## JOINT REGIONAL PLANNING PANEL (Sydney East Region)

<b>JRPP No:</b>	<b>2015SYE108</b>
<b>DA No:</b>	<b>DA15/0936</b>
<b>Local Government Area:</b>	<b>Sutherland Shire</b>
<b>Proposed Development:</b>	<b>Demolition of existing dwellings and ancillary structures and construction of two residential flat buildings containing 77 apartments</b>
<b>Street Address:</b>	<b>Lot 18 Sec A DP 2499, Lot B DP 384089, Lot 21 DP 881235, Lot 22 DP 881235, S/P 63259, Lot 1 S/P 63259, Lot 2 S/P 63259, Lot 3 S/P 63259 – 11 &amp; 11A – 15 Veno Street and 30 Rosebery Street, Heathcote</b>
<b>Applicant/Owner:</b>	<b>Globuild Pty Ltd</b>
<b>Number of Submissions:</b>	<b>Twelve (12)</b>
<b>Regional Development Criteria (Schedule 4A of the Act)</b>	<b>General Development over \$20 million</b>
<b>List of All Relevant s79C(1)(a) Matters</b>	<ul style="list-style-type: none"> <li>• Sutherland Shire Local Environmental Plan 2015 (SSLEP2015)</li> <li>• State Environmental Planning Policy No. 55 – Remediation of Land (SEPP 55)</li> <li>• State Environmental Planning Policy No. 65 – Design Quality of Residential Flat Development (SEPP 65)</li> <li>• Apartment Design Guidelines (ADG)</li> <li>• State Environmenta

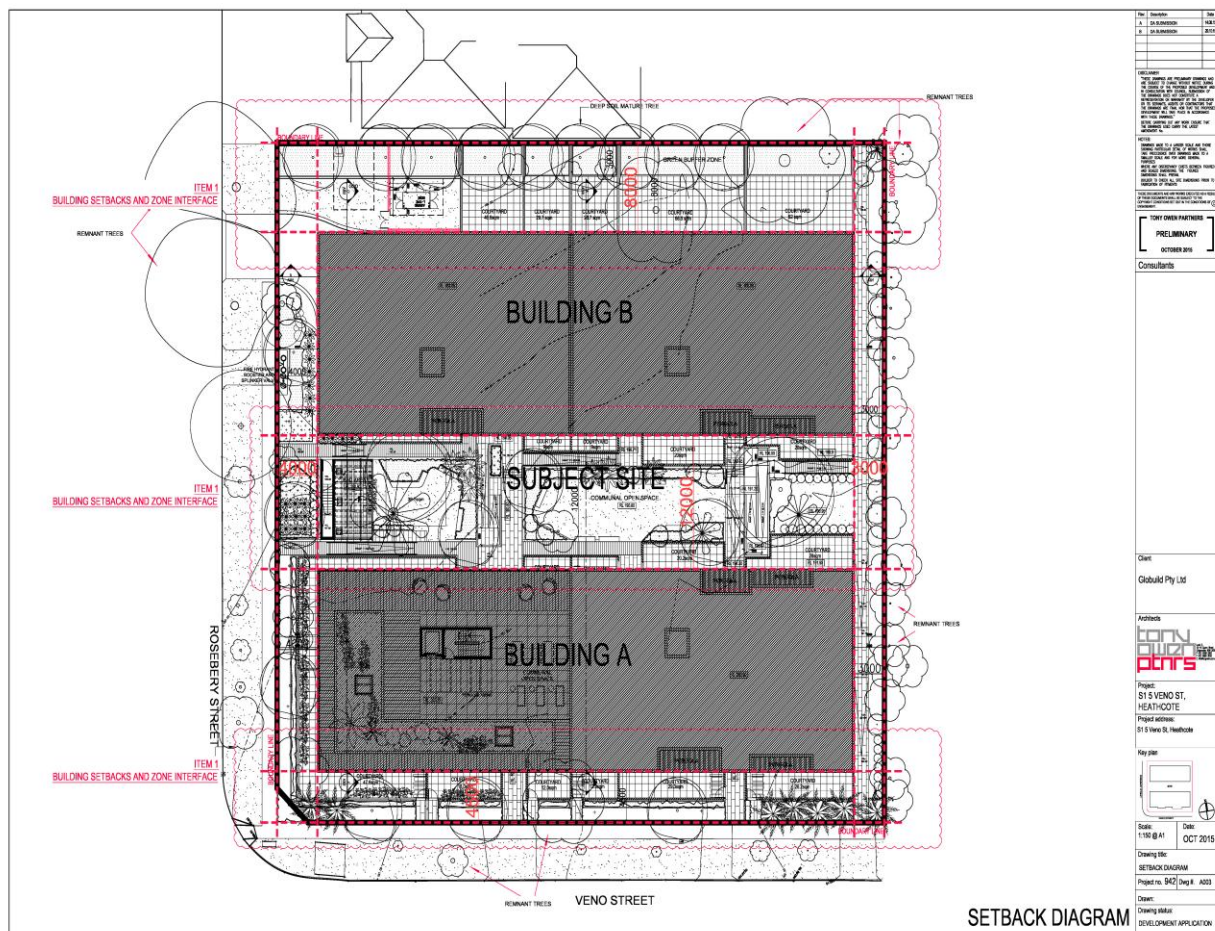
The proposal entails several departures from the relevant LEP, DCP and ADG controls being mainly building height, separation and setbacks. On balance, this assessment considers that the site is suitable for a building of the type, use and size proposed, subject to the imposition of appropriate conditions of consent, including minor increases in building setback at the most sensitive edges and the modification of some units to improve solar access, as well as a significantly improved scheme of landscaping.

The applicant has modified the building as originally proposed in response to concerns raised by Council staff.
